ADDENDUM No. 1

November 20, 2017

PROJECT: WEST GATE ENTRANCE EXTERIOR IMPROVEMENTS-FENCING PACKAGE
BEXAR COUNTY ARENAS

METAL FENCE POST
BASE PLATE DETAIL AT EXISTING
CONCRETE FLATWORK S-103

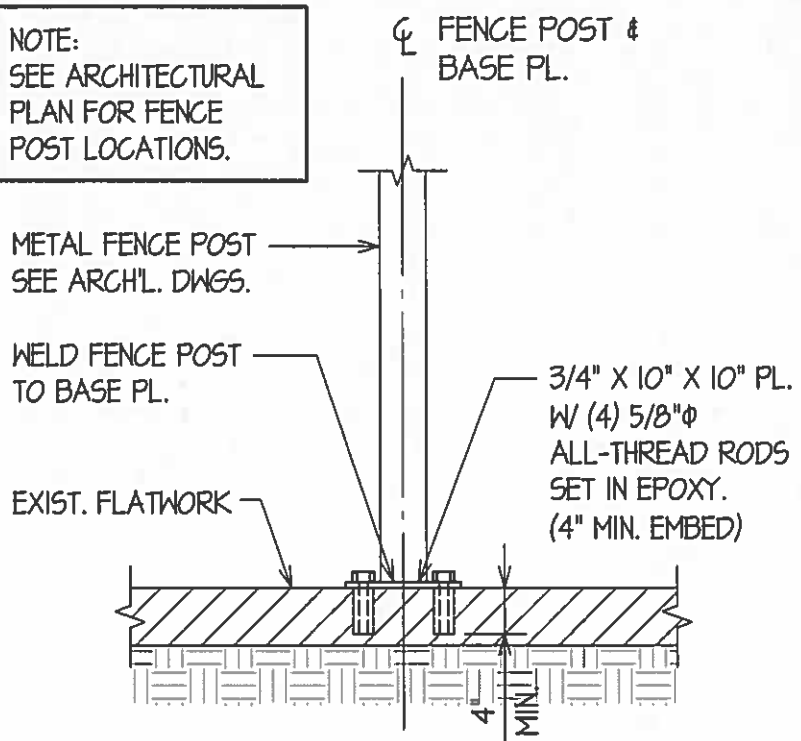
- AD1.3 Drawing Sheet A-1.1: Add note to Details "2" and "5" to read:
"See Detail 'S-103' for anchoring fence posts to concrete flatwork."
- AD1.4 Drawing Sheet S-1: Add Detail "S-103" as per Attachment "AD1.A".

NOTE:
SEE ARCHITECTURAL
PLAN FOR FENCE
POST LOCATIONS.
